FORD E4OD "UPDATE HANDBOOK"

*Updated
April, 2004*

VALVE BODY, SPACER PLATE, SPACER PLATE GASKETS, CHECKBALL LOCATIONS, AND CASE CHANGES, FOR THE 1996 MODEL YEAR

Figure 8

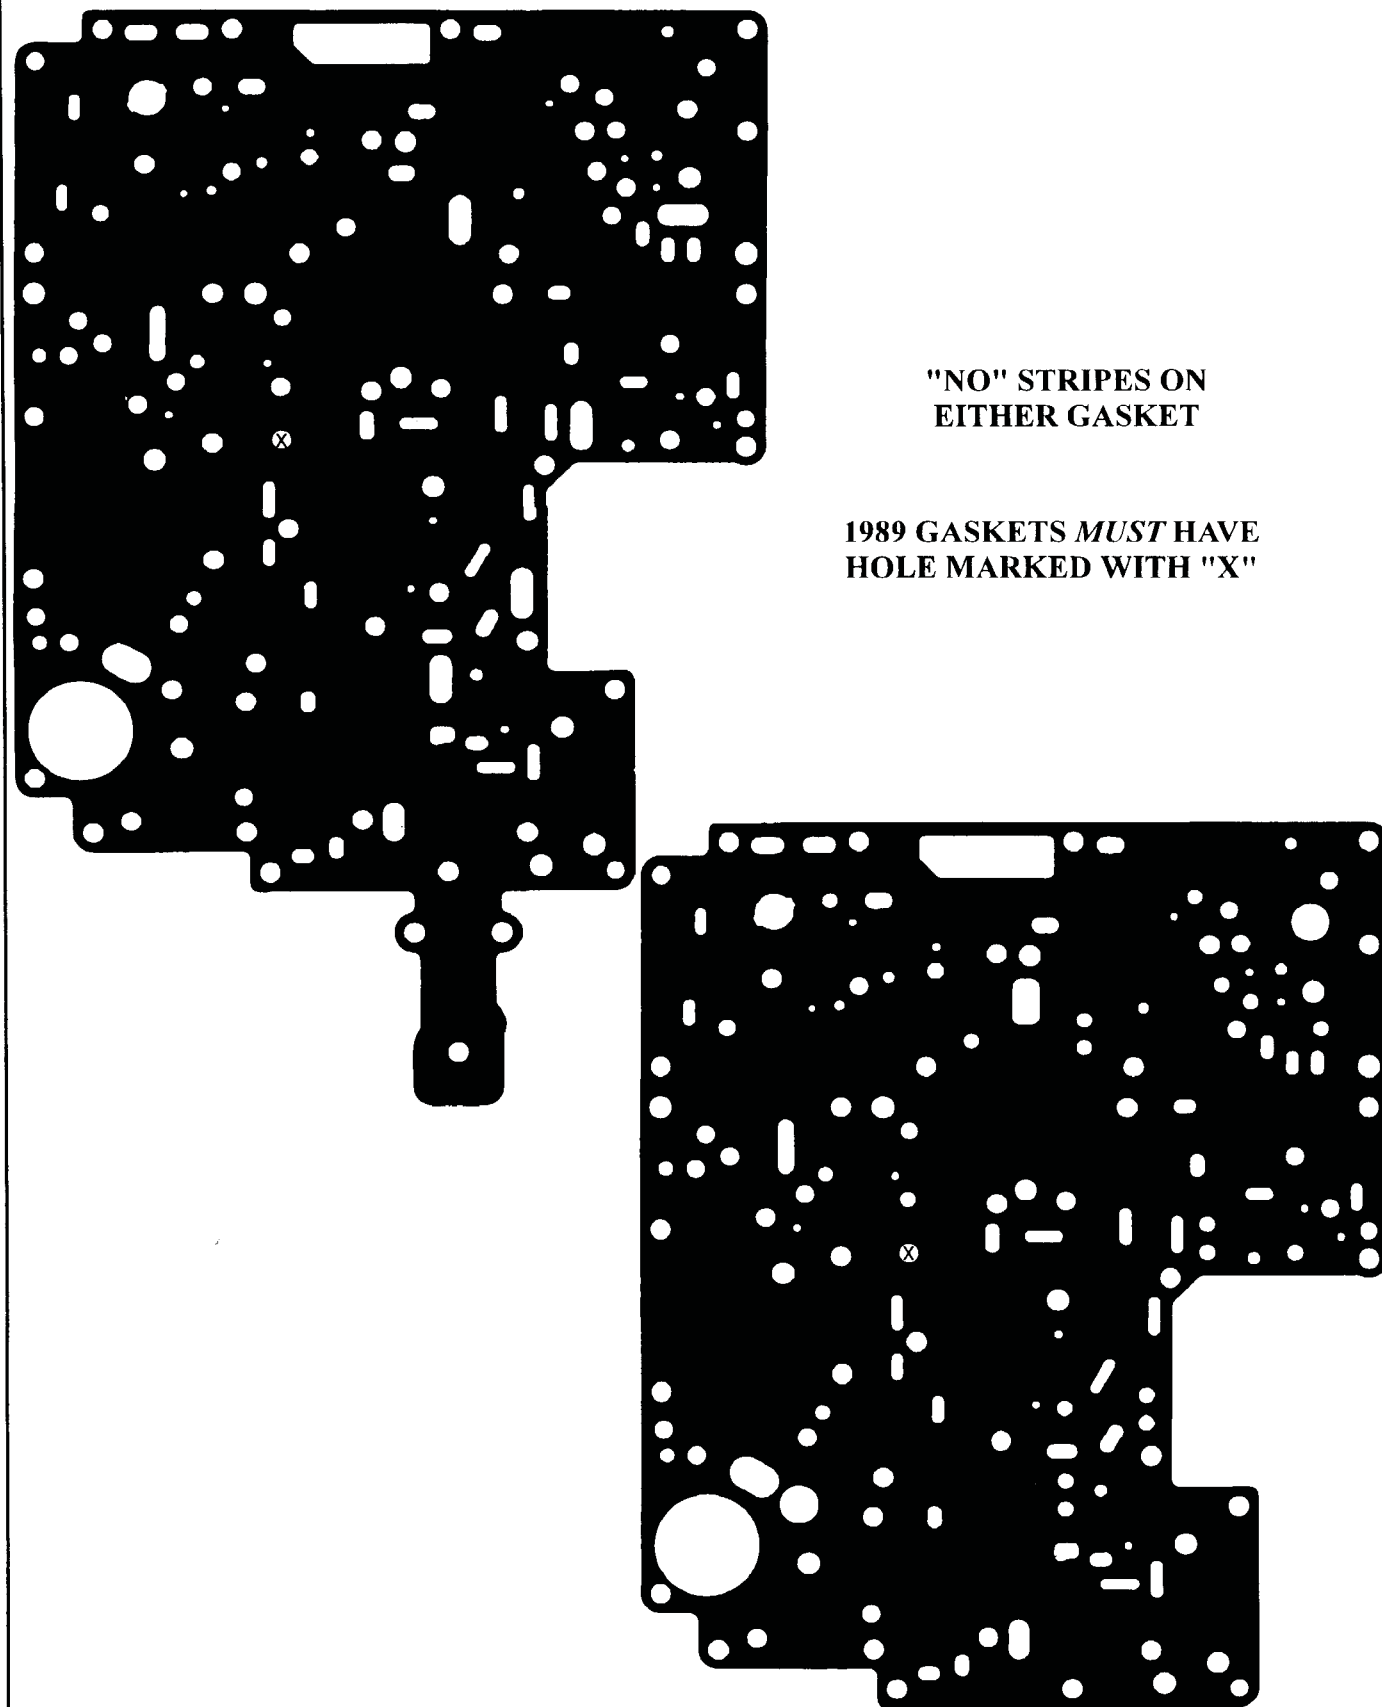
1989 Models Only - Require the Spacer Plate Gaskets with solenoid feed hole (Marked X) in the location shown in Figure 8, and the gaskets have **No I.D.** stripes on either gasket.

Figure 9

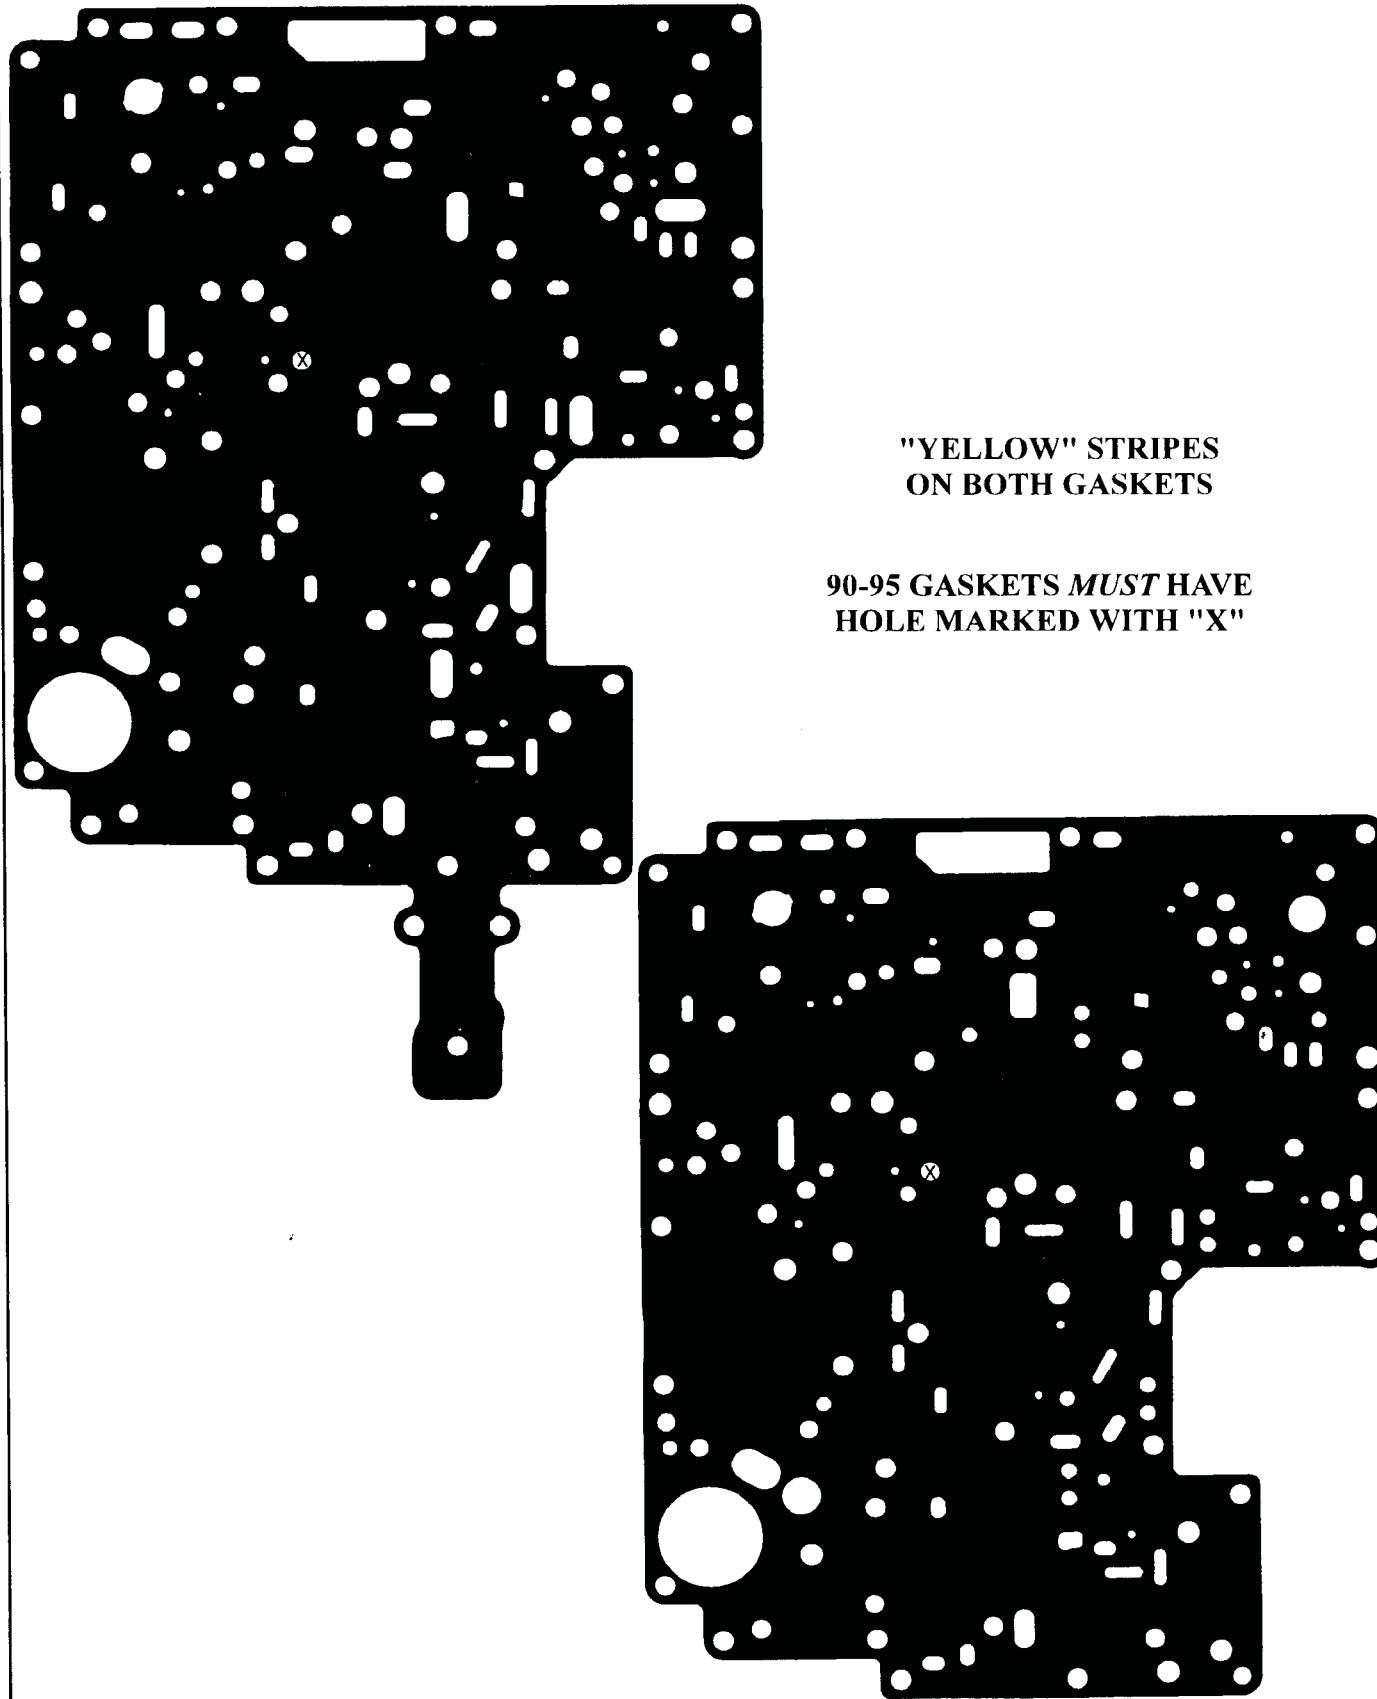
90-95 Models Only - Require the Spacer Plate Gaskets with solenoid feed hole (Marked X) in the location shown in Figure 9, and both gaskets have **Yellow I.D.** stripes

Figure 11
AUTOMATIC TRANSMISSION SERVICE GROUP

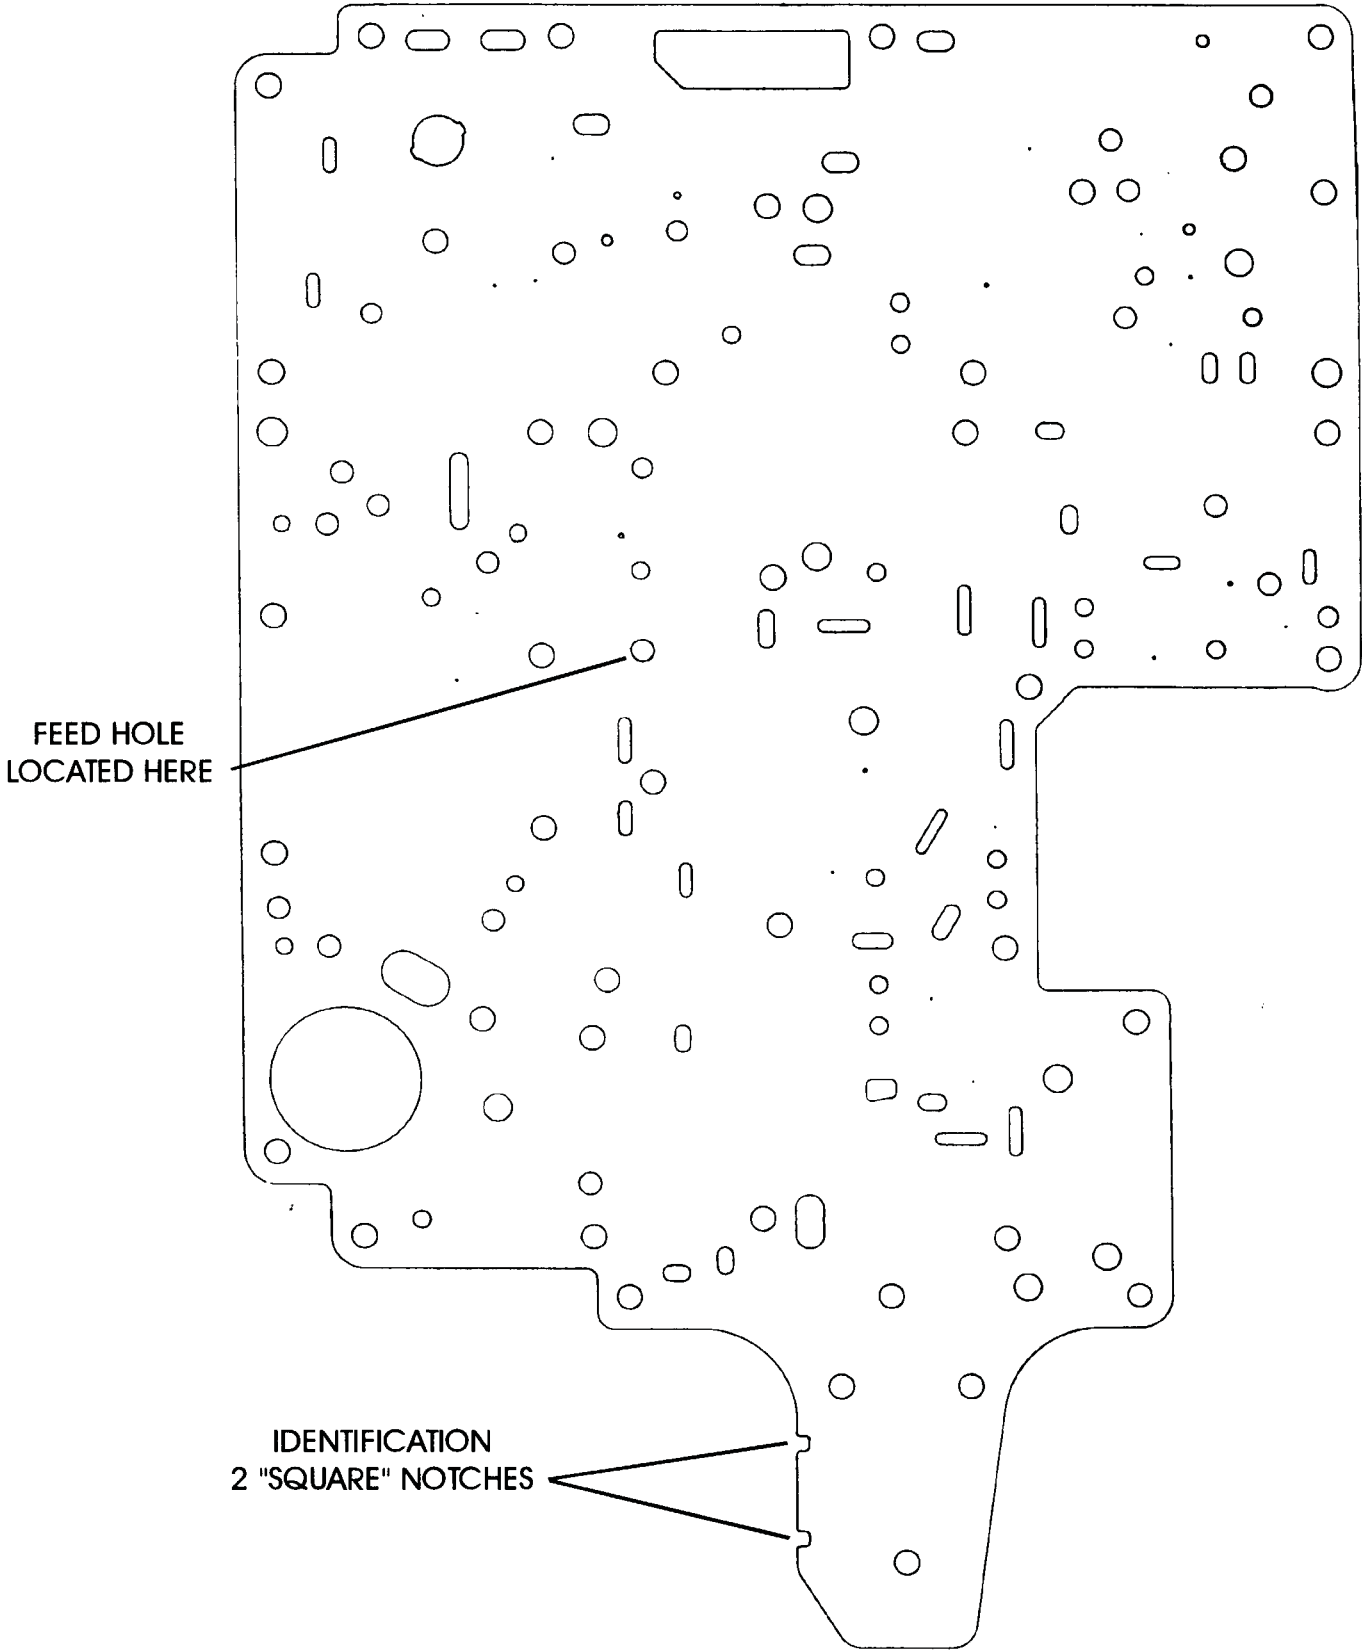
- (4) **MAIN VALVE BODY SPACER PLATE**- Has changed twice since the introduction in 1989.
1989 Models Only - Requires the Spacer Plate with the solenoid feed hole in the location shown in Figure 11, and has two "Square" notches for identification
90-95 Models Only - Requires the Spacer Plate with the solenoid feed hole in the location shown in Figure 12, and has two "Half Moon" notches for identification. Note; Some models have two "V" notches with one "Half Moon" notch between them for identification.
1996-UP Models Only - Requires the Spacer Plate with the three "V" notches for identification as shown in Figure 13, and has a multitude of hole location changes.

Figure 14

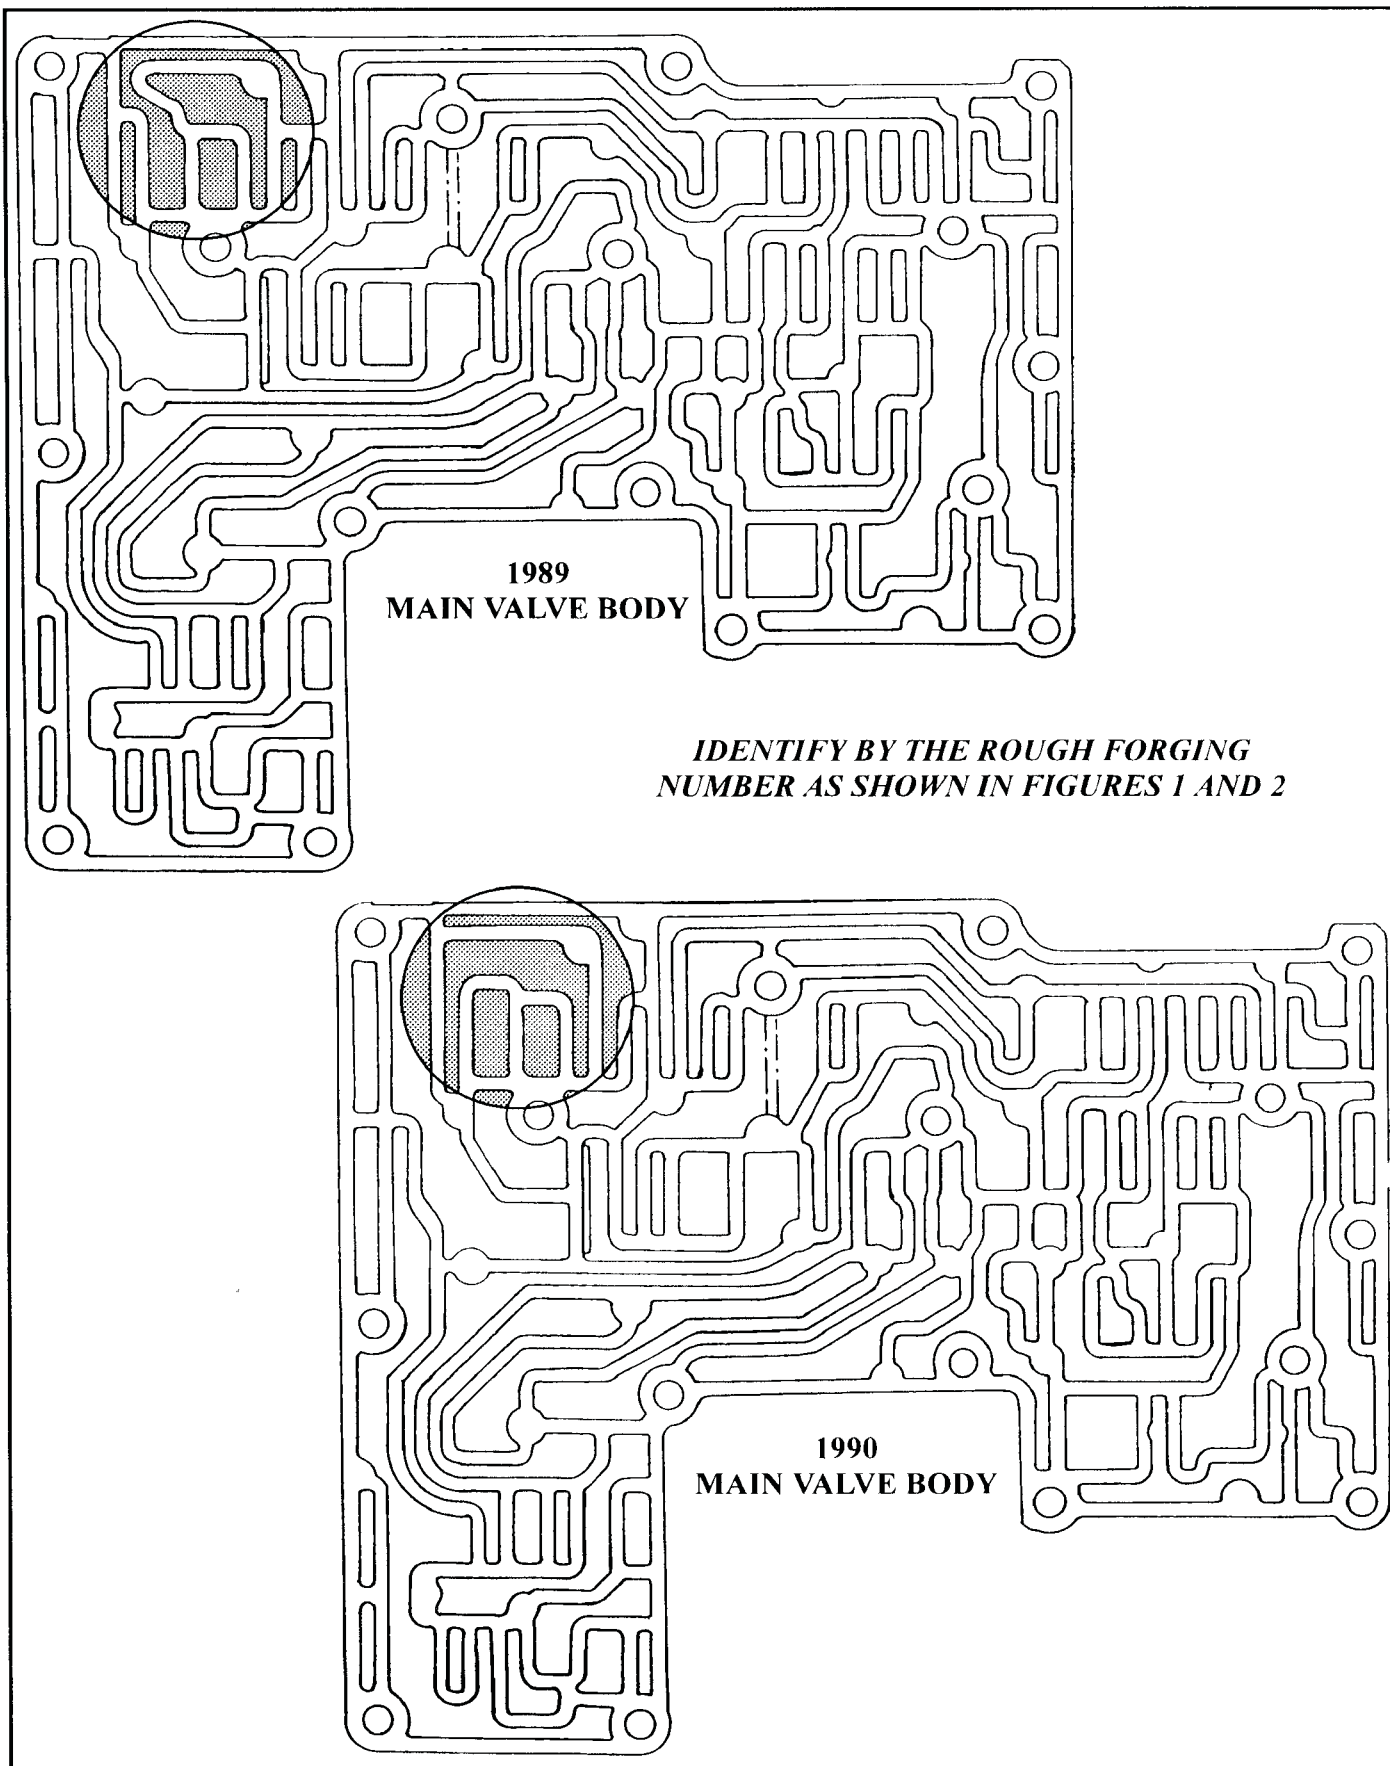
- (5) **MAIN VALVE BODY** - Has changed twice since the introduction in 1989 as listed below.
1989 Models Only - Can be identified by the differences in the worm track area at the 1-2 shift valve, as shown inside the circles in Figure 14. The best, and most accurate method to identify the valve body, is the rough forging number cast into the valve body in the location shown in Figures 1 and 2.
90-95 Models Only - Can be identified by the differences in the worm track area at the 1-2 shift valve, as shown inside the circles in Figure 14. The best, and most accurate method to identify the valve body, is the rough forging number cast into the valve body in the location shown in Figures 1 and 2.
1996-UP Models Only - Has a multitude of worm track location differences from the previous models, as shown in Figure 15. The best and most accurate method to identify the valve body, is the rough forging number cast into the valve body in location shown in Figures 1 and 2.
